Modification Bulletin

40-0053 - MB - EUR/US - YTxx3 DOT - CAM0196 replacement relay K03 12V

**Replacement relay K03 12V
YTxx3 DOT**

figure 5, compare position in real life with label

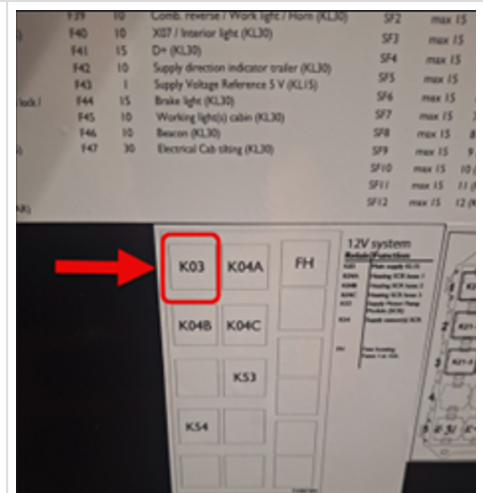
4. Check on the rear side of the relay block whether relay K03-12V is installed in the correct position, based on the existing relay label. The wires running to the relay block should indicate K03-12V (see figures 3, 4 and 5)

5. Remove the current relay from the K03-12V position. See figure 5.

6. Install relay t25035235 in the K03 -12V position.
